SLR Consulting Australia

Project No. 610.V30951.00303

RE: Acoustic Assessment Methodology Memorandum

Figure 1 Site Location, Surrounding Receivers and Noise Monitoring Locations

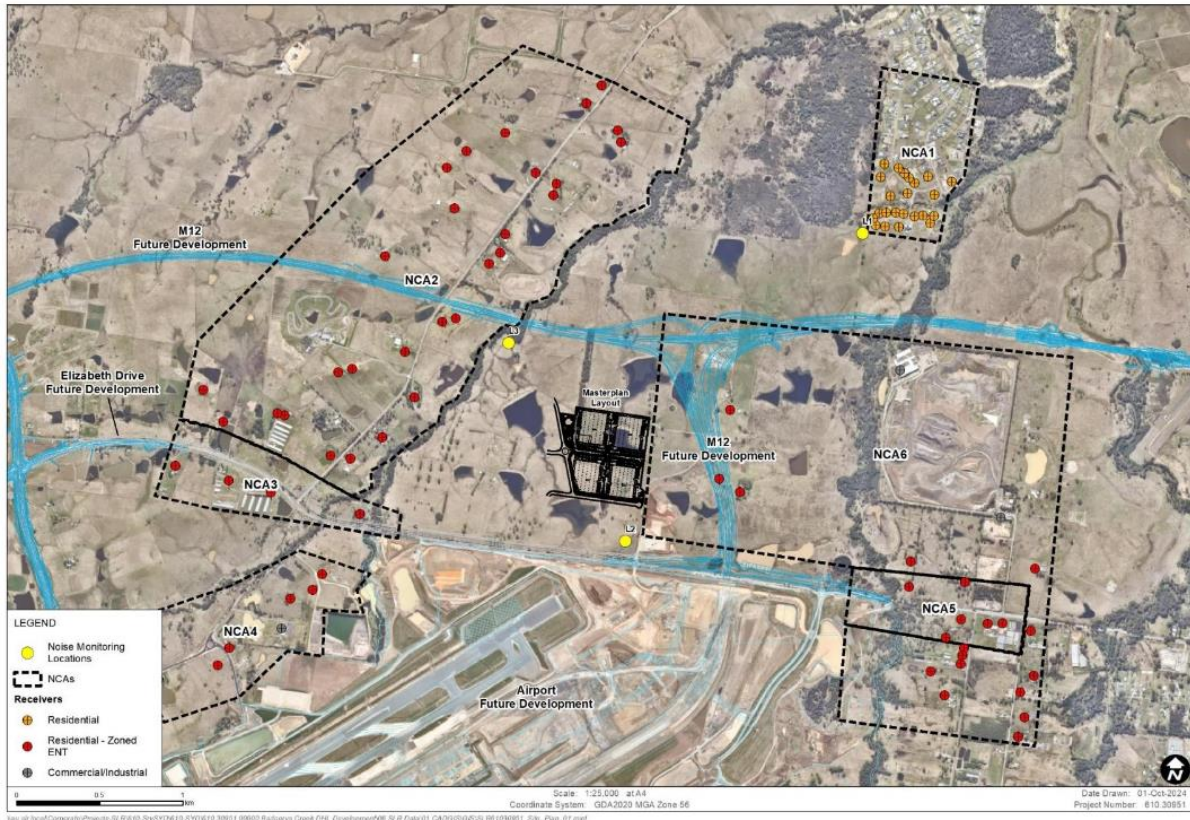
Noise – the assessment approach and noise limits are different in the report prepared by EMM for Burrah Park and the report prepared by SLR for this EIS.

It is understood that EMM Consulting's assessment of the Burra Park masterplan have only considered the residential receivers within the Twin Creeks estate northeast of the site, depicted as NCA1 in **Figure 1** and have not considered the remaining residents located east and west of the site within land zoned as Enterprise.

This approach by EMM Consulting assumes that these residents are temporary and will be demolished as part of the Aerotropolis precinct upgrades once Burra Park is operational. However, DPHI's review of EMM's report have indicated that these temporary residential receivers will need to be assessed. In relation to this, SLR's approach satisfies these requirements as previously discussed in **Section 3.0**.

As a result, the noise catchment areas (NCAs) proposed within SLR's assessment depicted in **Figure 1**, capture all residential receivers north-east of the site that are to be retained once the Aerotropolis transition is complete, but also includes existing residential receivers east and west of the site that are likely to be removed once the transition is complete. The permanency of sensitive receivers should be considered to best optimise the recommended acoustic mitigation measures where required.
